SERVICE BULLETIN

TB AIRCRAFT

SB 10–129	79 <small>ATA No.</small>
------------------	-------------------------------------

SUBJECT : MEDIAMATE PRESSURE TRANSMITTER

Figure 1 – Modification of wiring

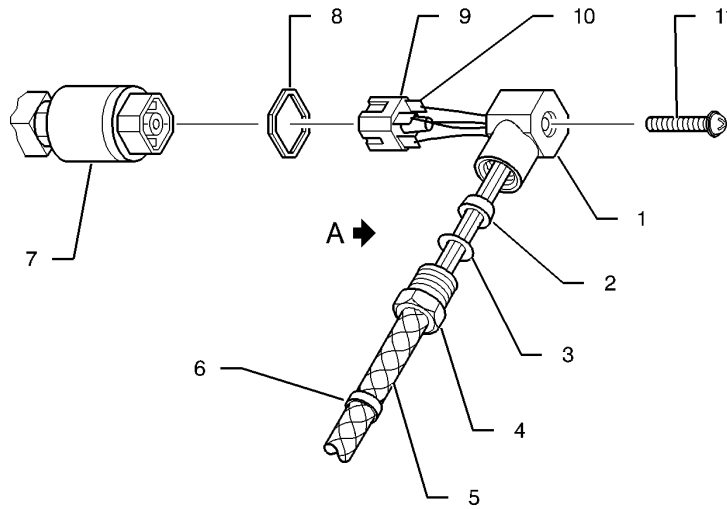
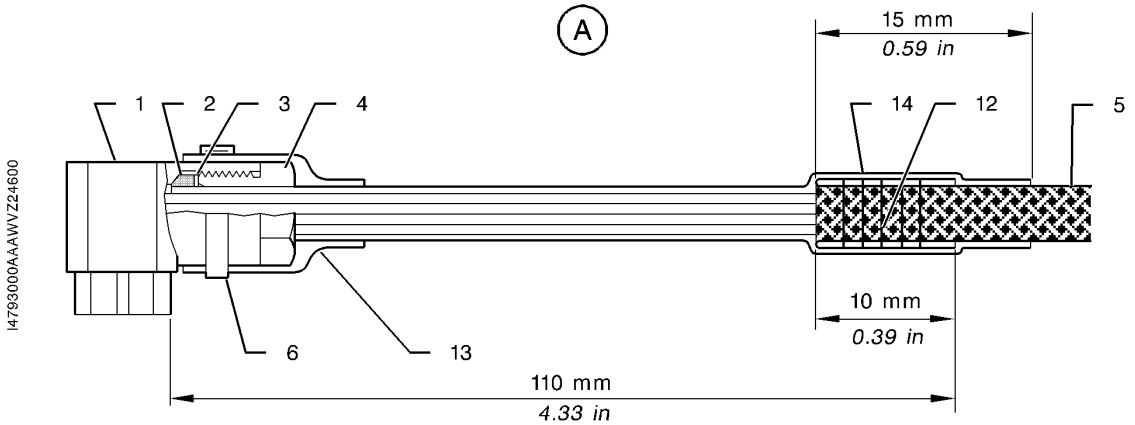
Possibility of pressure erratic indication : falling down to zero or increasing up to the maximum of indicator scale.

Contamination of pressure transmitter by humidity.

Dry and seal aircraft harness connector to avoid infiltration of humidity into pressure transmitter connector.

A. PROCEDURE – see Figure 1

- 6) Using masking tape, mark position of textile sheath (5) turning over end at 4.33 in (110 mm) from connector (9).
- 7) Remove screw (11), unscrew nut (4) and pull it back with textile sheath (5).

- 13) Turn over end of textile sheath (5) on about 0.39 in (10 mm) from masking tape mark and bind with shrinking wire (12), P/N Z00.N4391560023. Cut excess textile sheath (5) and remove adhesive tape.

- stud 3 : yellow wire,
 - stud 4 : white wire.
- 17) Position heat–shrinkable tubing (10) pieces on studs and shrink them.
- 18) Position heat–shrinkable tubing (14), close to weldings so that it can be compressed by packing gland (2) and make sure it overlaps turned over and bound textile sheath (5) end by 0.59 in (15 mm).

Figure 1 – Modification of wiring

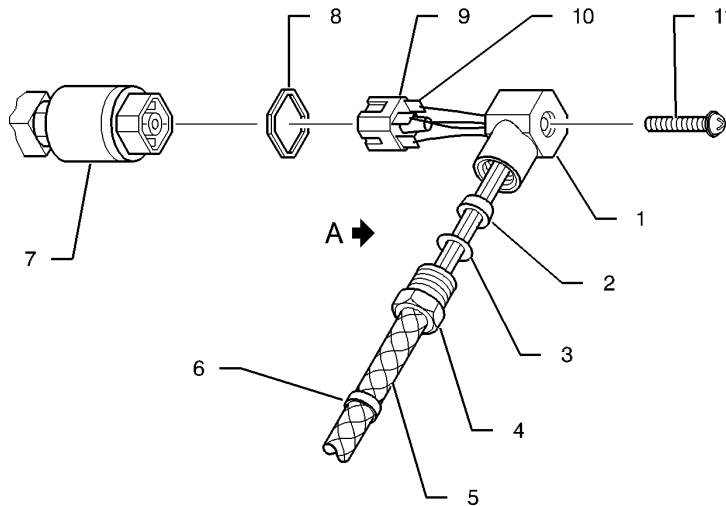
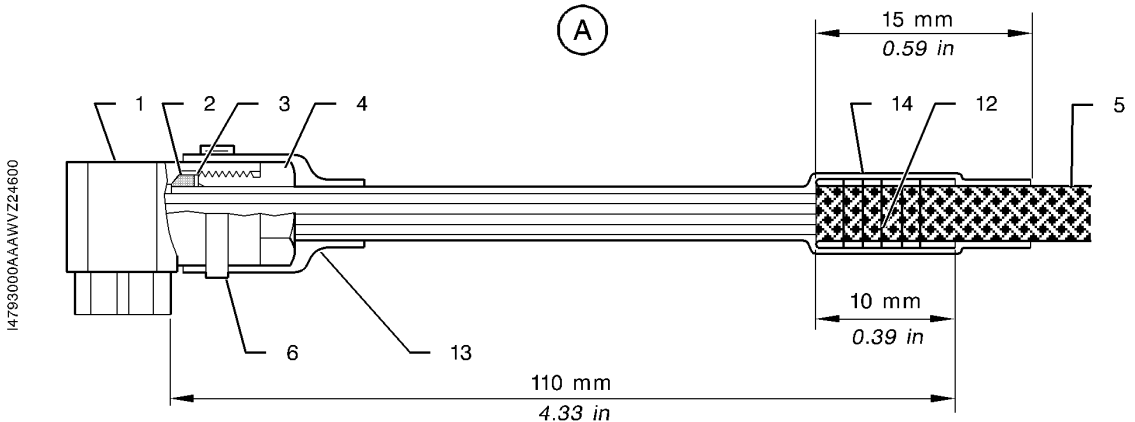
Possibility of pressure erratic indication : falling down to zero or increasing up to the maximum of indicator scale.

Contamination of pressure transmitter by humidity.

Dry and seal aircraft harness connector to avoid infiltration of humidity into pressure transmitter connector.

A. PROCEDURE – see Figure 1

- 6) Using masking tape, mark position of textile sheath (5) turning over end at 4.33 in (110 mm) from connector (9).
- 7) Remove screw (11), unscrew nut (4) and pull it back with textile sheath (5).

- 13) Turn over end of textile sheath (5) on about 0.39 in (10 mm) from masking tape mark and bind with shrinking wire (12), P/N Z00.N4391560023. Cut excess textile sheath (5) and remove adhesive tape.

- stud 3 : yellow wire,
 - stud 4 : white wire.
- 17) Position heat–shrinkable tubing (10) pieces on studs and shrink them.
- 18) Position heat–shrinkable tubing (14), close to weldings so that it can be compressed by packing gland (2) and make sure it overlaps turned over and bound textile sheath (5) end by 0.59 in (15 mm).
